**Assessment of Four (4) Protected-Size Trees
at
102 Alta Heights Court
Los Gatos, California**

Prepared for:
Mr. Ryan Safty, Associate Planner
Town of Los Gatos Community Development Department
110 E. Main Street
Los Gatos, CA 95030

Field Visit:
Walter Levison, Contract Town Arborist (CTA)
10/25/2020

Report by CTA
11/3/2020

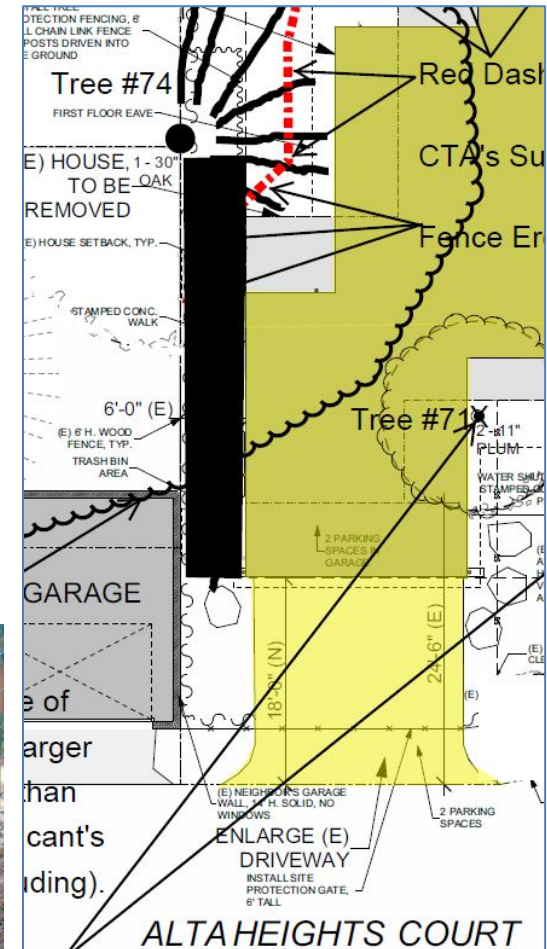
The ground protection shall be set up over the entire west side yard of the site, between tree #74 trunk, and southward to the proposed driveway (see black rectangle area on the markup at right).

- Geotextile fabric laid down over the ground.
- 6 inches thickness wood chip mulch laid over the geotextile.
- 1 inch thick exterior grade plywood boards (full sheets), set side by side over the wood chips.
- Steel screw plates to affix the plywood sheets together, side by side.
- (See photo at right for example of correctly-installed soil buffer on a site where trees were protected using chain link fence panels, trunk buffers, and the complete soil buffer system as described on this page.

The CTA marked up the applicant's new residence plan sheet A1.0 dated 10/13/2020, as the background for the tree map markup.

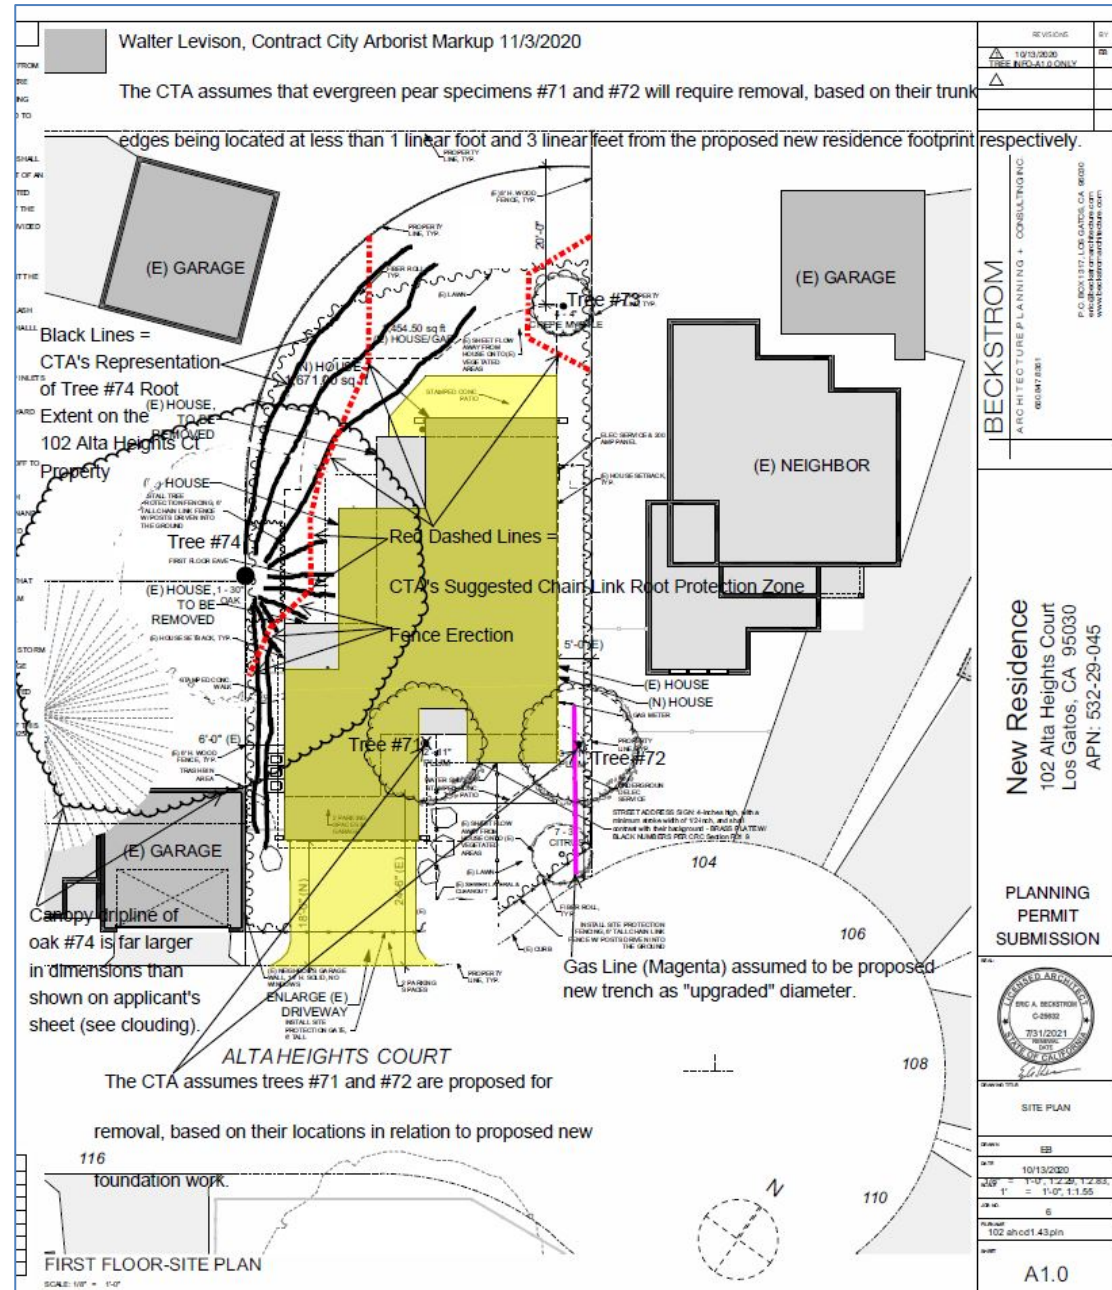
The canopies of trees #71 and #72 as indicated on the applicant's sheet A1.0 is not accurate. The canopy spread of each of those trees is actually 30 feet diameter. The applicant's sheet A1 indicates canopy spreads of only 18 feet diameter for each of these trees.

Note that the canopy dripline of oak #74 is far greater in dimensions than shown on the applicant's original proposed sheet A1.0.

The black clouding indicating on the CTA's markup at right is roughly to scale, and is a more accurate albeit crude representation of the extent of this very large tree specimen.

The tree protection fencing will need to be erected at roughly 7 to 8 feet east of trunk of oak #74, but will extend 50 feet northward per the markup at right, in order to protect as much square footage of the tree's lateral woody root system extending along the 102 Alta Heights Ct. property.

Note: As indicated above in this report, the applicant's original sheet A1.0 shows the canopy driplines of trees #71, 72, and #74 at dimensions far smaller than actual. The CTA enlarged the tree #74 canopy in the marked up image at right to rough-scale dimensions.
